New Albany Planning Commission Agenda
Monday, March 18, 2024 at 7:00 p.m.

**New Albany Planning Commission
DRAFT March 4, 2024 Informal Meeting Minutes**

**Planning Commission Staff Report
March 4, 2023 Meeting**

**COURTYARDS AT HAINES CREEK SUBDIVISION
FINAL DEVELOPMENT PLAN**

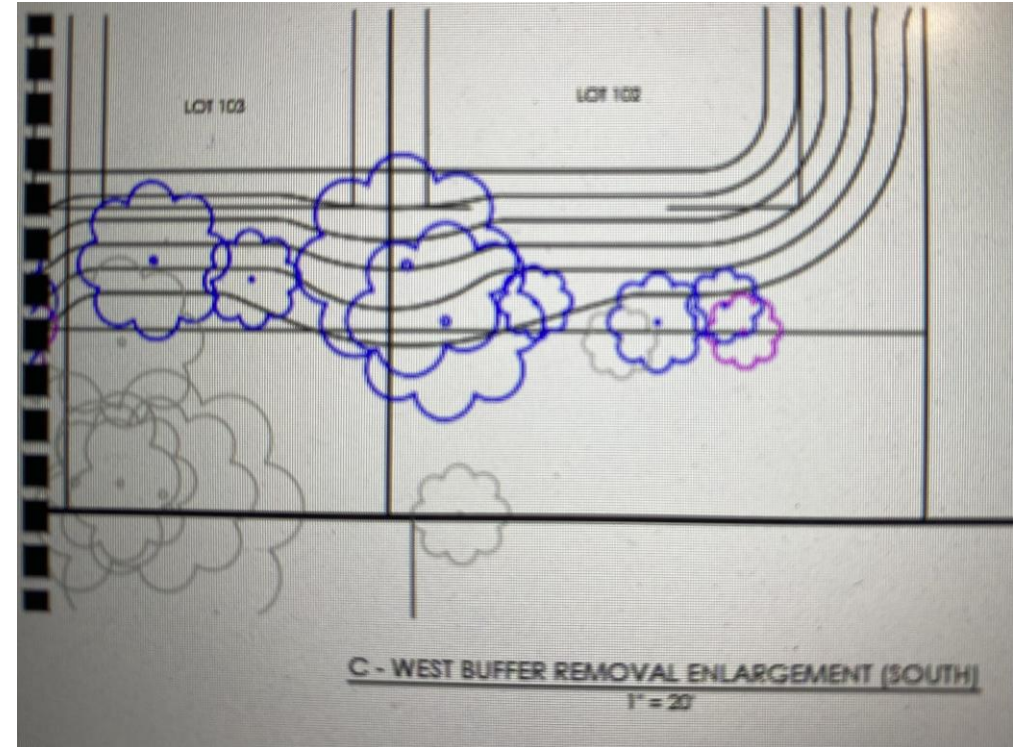
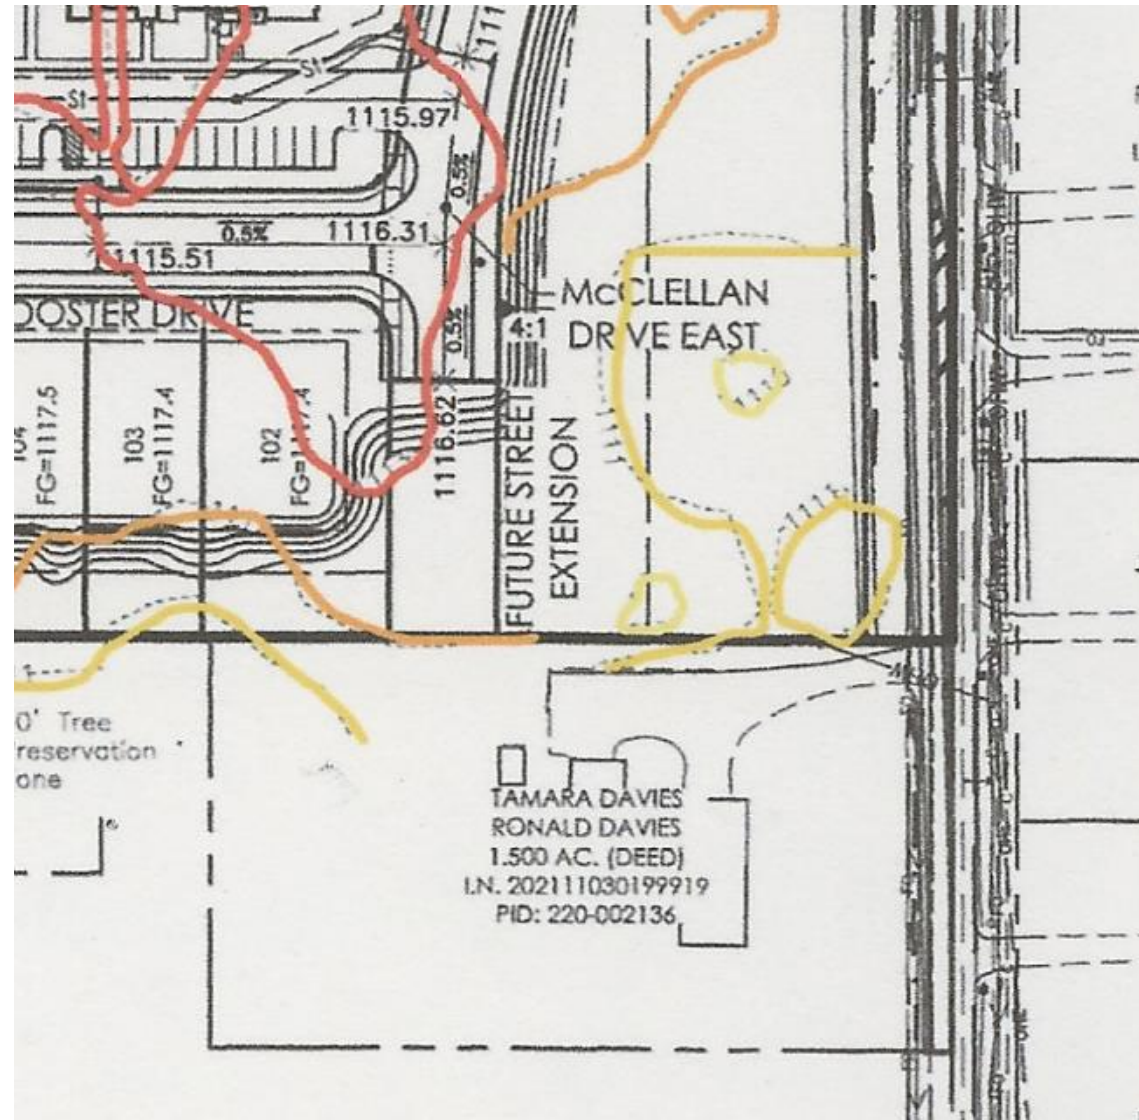
$$1118 - 1110 = 8 \text{ft}$$

$$9164 \text{ft}^2 \times 8 \text{ft} = 73312 \text{ft}^3 \text{ or } 2715 \text{ cubic yards}$$

$$\text{Dump truck load} = 10 \text{ to } 14 \text{ cubic yards}$$

Therefore lot #113 will need 194 to 272 dump trucks full of dirt.

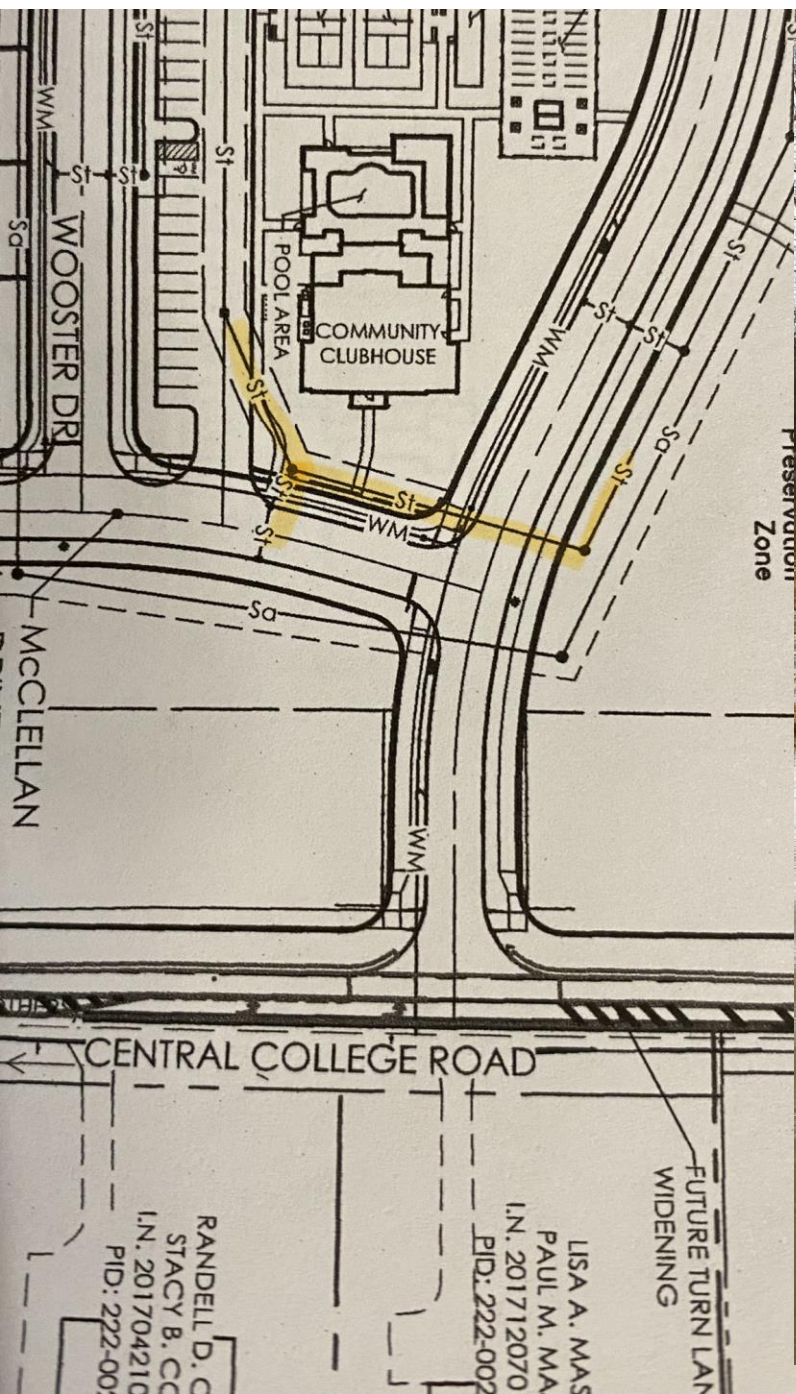
The home on lot# 102 will be 7 feet higher than the home at 8238 Central College Rd

The road stub will be 7 feet above grade for our home at 8238 Central College Rd. This disparity negatively effects the home's value.

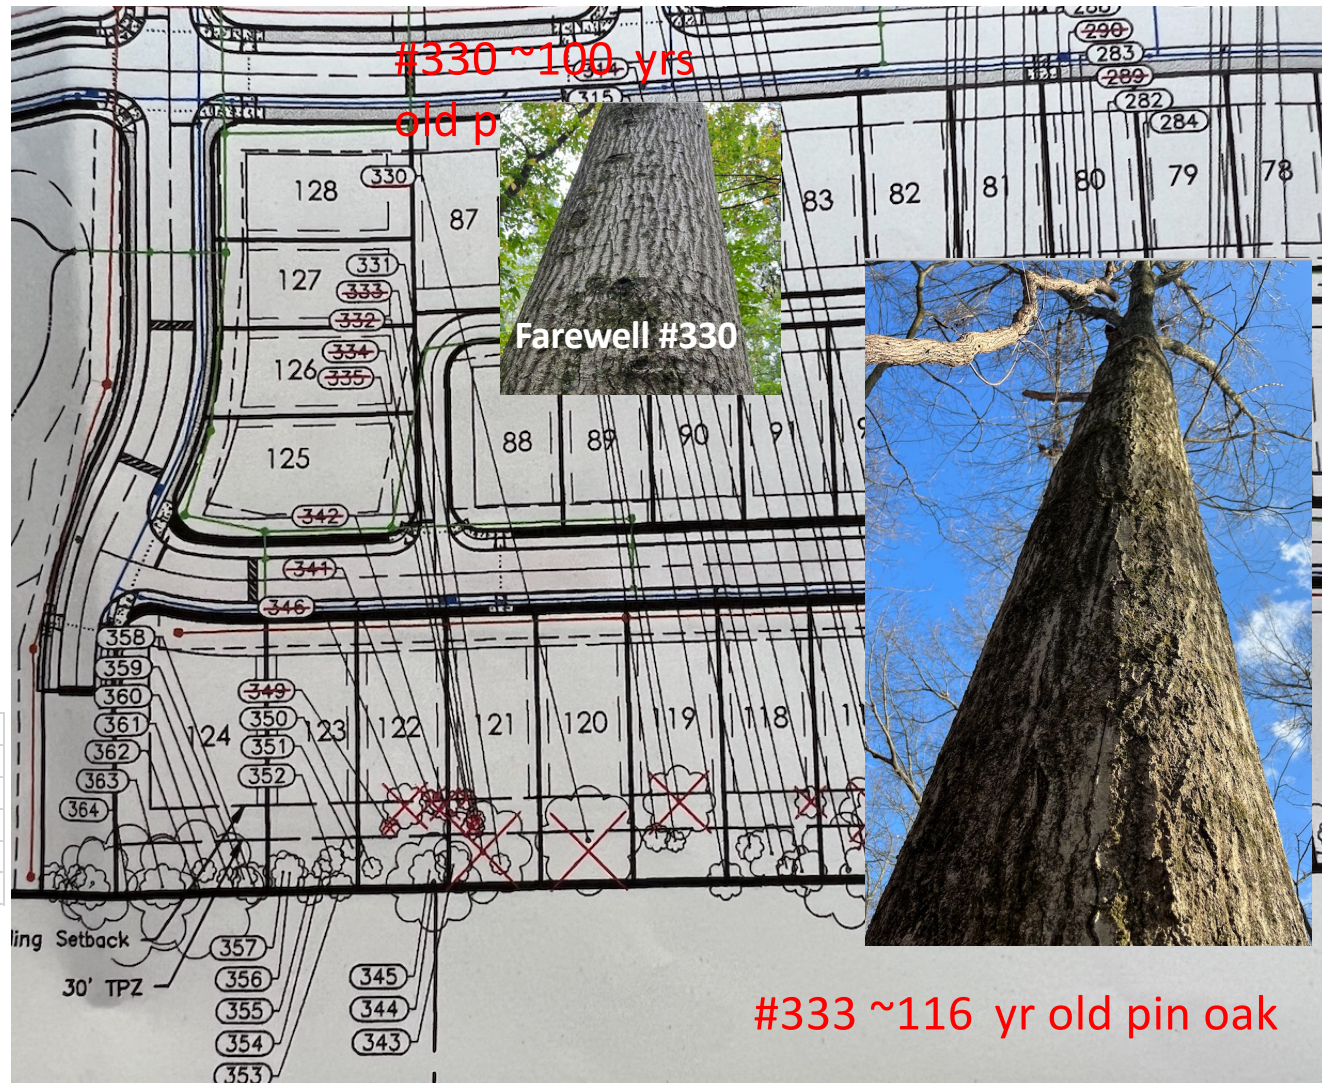
- Why is the city allowing the removal of 330 & 333?
- Both in tree protection zone
- Both in good condition (per Arborist)
- ~93 & 116 yrs old

Survey #		Trunk size		Age
175	Pin Oak	6	Poor	18
194	Pin Oak	12	Fair	36
221	Silver Maple	17, 15, 11, 11, 9	Good	51
330	Pin Oak	31	Good	93
333	Red Oak	29	Good	116

Right of Way (RoW)usage

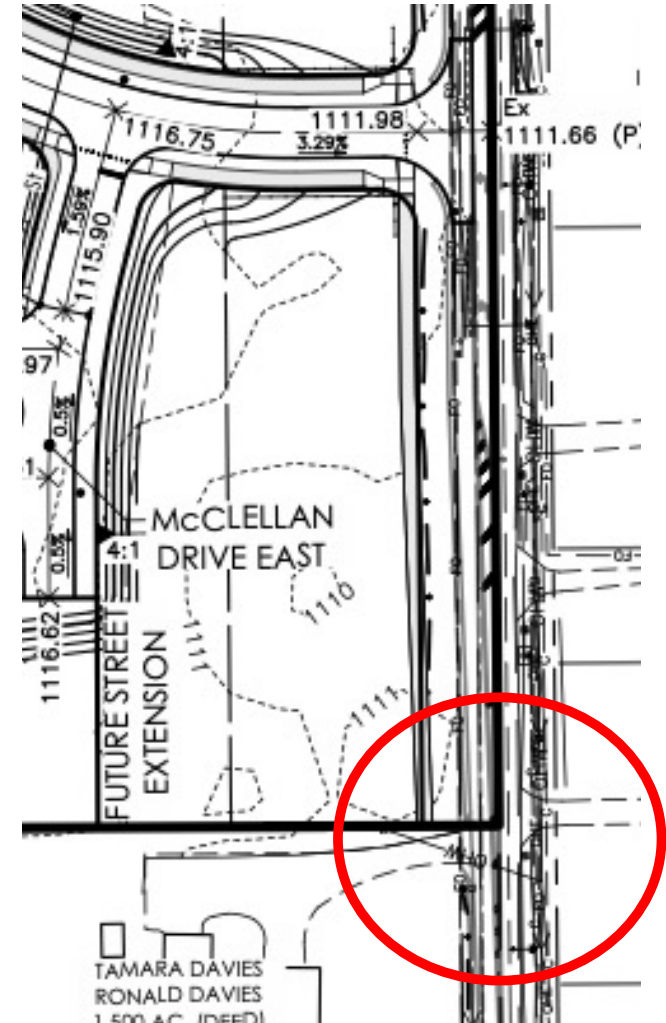
- As applicant notes –
 - “no improvements are necessary to the existing roadway”
 - “An Eastbound left turn lane....is warranted...2034”.
- Yet the City seems to ignore the study and is asking for a left turn lane now.
 - Has anyone studied the timing of the traffic patterns?
 - We would note our observations that traffic is east bound at 6:30 AM (morning commute) and reverse in the PM.
 - So an east bound left turn lane does nothing unless there is a high degree of east bound traffic turning into this project early in the morning. (this is in conflict with Applicant’s statement that 55+ communities generate less car trips on average.
- This requires the use of a RoW on the North side of CC that is not in New Albany.
- Could we expect a courtesy note that there may be impact on 8238 Central College’s driveway (note: 8238 is not in New Albany), the drain lines etc....?

Woodland Protections

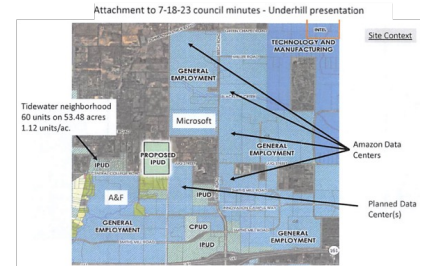
- Red Box ~11 acres
- White box – same size as red box.
- Applicant wants to clear cut majority of trees in the white box.
- Current plan does not retain substantial woodlands
